- 4. Willard's Legacy; KPB File 2024-011
Seabright Surveying / Jones, Cissney
Remote Location
Fox River Area**

**ITEM #4 - PRELIMINARY PLAT
WILLARD'S LEGACY**

KPB File No.	2024-011
Plat Committee Meeting:	February 26, 2024
Applicant / Owner:	Trisha Jones and Lacy Cissney of Homer
Surveyor:	Katherine Kirsis / Seabright Survey + Design
General Location:	South Shore of Caribou Lake

STAFF REPORT

WILLARD'S LEGACY

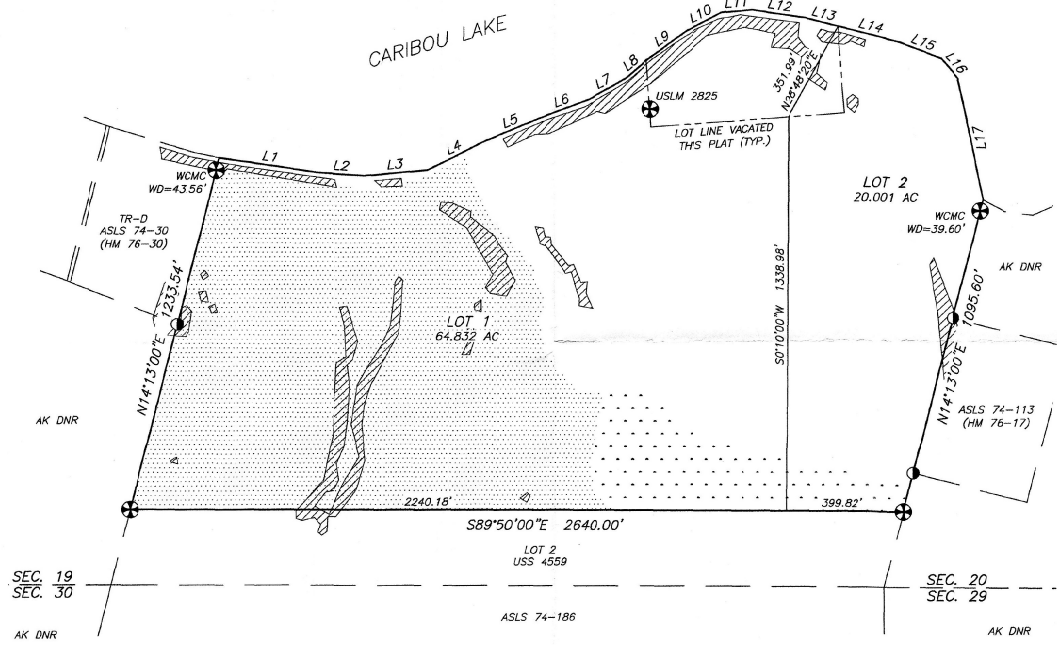
The plat is located in a remote location on Caribou Lake. No direct access is available to the plat. Small plane may be used to land on Caribou Lake and there are indications of trails to the structures on adjacent plats and aerial photos. Please note these on the plat. If the trails noted on adjacent surveys are still in use and are to be shown on the plat are private trails, **staff suggests** the following note be placed on the final plat to avoid confusion about public use in the future: 'Private trails shown are for use of owners only and are not dedicated to public use.'

There are steep areas on the plat as shown by the hatched boxes shown on the drawing. The steepest areas are located near the edge of the lake, as KPB contour mapping shows steepest spots near the structures.

Wetlands are indicated on the plat drawing with a designation of discharge slope and disturbed as identified from the KWF Wetlands Assessment, KPB GIS date. **Staff recommendation:** *place a note on the final plat indicating any person developing the property is responsible for obtaining all required local, state, and federal permits, including a U.S. Army Corps of Engineers wetland determination if applicable.*

Plat note 3 indicates the property to be in a FEMA FIRM mapped flood hazard area. KPB River Center did not indicate such designation, so note 3 can be removed. If the surveyor believes different, please contact the KPB River Center Flood Management desk.

Change KPB file no to 2024-011 in the title block

- Verification section line easements do not affect this subdivision should be done by surveyor on the land patent issued to George W. Willard.
- There are trails shown on US Survey 4559, if these are still in use or existence, they should be located and shown.

- Show the approximate location of the section line between 19 & 20 on the drawing
- Label land to the west as 'unsub'

- The borough will not enforce private covenants, easements, or deed restrictions per KPB 20.60.170.
- Plat note 3 is note necessary as the area was not designated as a flood hazard area district. If the surveyor believes the parcel to be in a flood hazard area, please contact the KPB River Center Floodplain Management.
- If the trails noted on adjacent surveys are still in use and are to be shown on the plat are private trails, **staff suggests** the following note be placed on the final plat to avoid confusion about public use in the future: Private trails shown are for use of owners only and are not dedicated to public use.

Add the date of February 26, 2024 to the Plat Approval note.
